Charlotte Department of Transportation

Memorandum

Subject: Rezoning Petition 07-145: Located on the southwest corner of Mt. Holly-Huntersville Road and West. W.T. Harris Boulevard (revised 12/14/07)

WT Harris Boulevard Future Road Extension and Alignment
MUMPO Thoroughfare Plan

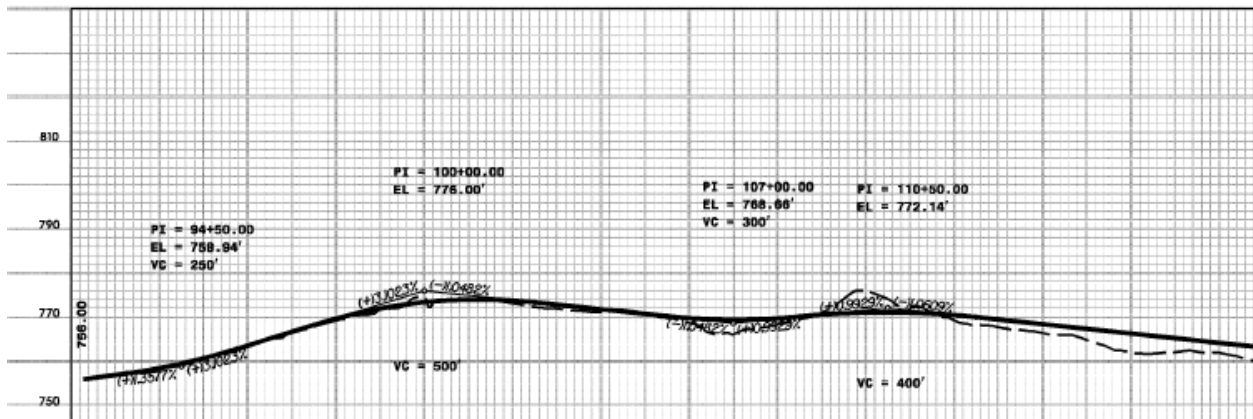
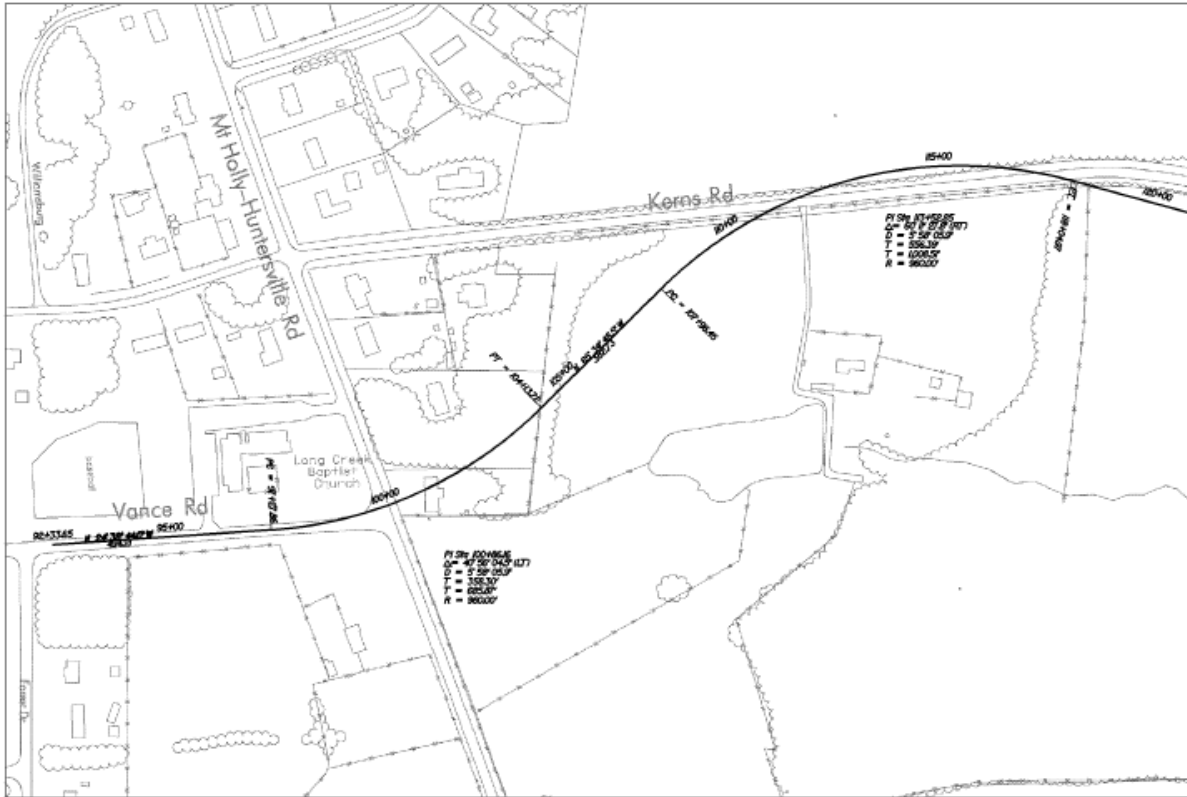
3. WT Harris Boulevard is shown on the Mecklenburg-Union Metropolitan Planning Organization (MUMPO) Thoroughfare Plan as being realigned in this location. It is our understanding that there is an approved alignment for this roadway that will impact this property along both roadway frontages. Developer/petitioner needs to contact Stuart Basham of MUMPO at 704-336-4695 to obtain this alignment. In order for us to continue our review of this petition, the site plan needs to be revised to show the proposed thoroughfare realignment in the next submittal. We request that the petitioner dedicate this right-of-way, 70 feet from centerline on Mount Holly-Huntersville Road and 60 feet from the new alignment centerline on WT Harris Boulevard. This thoroughfare realignment needs to be shown on the next site plan submittal (see attached aerial photograph and realignment plan below). (*Previous Review Comment – 1*)
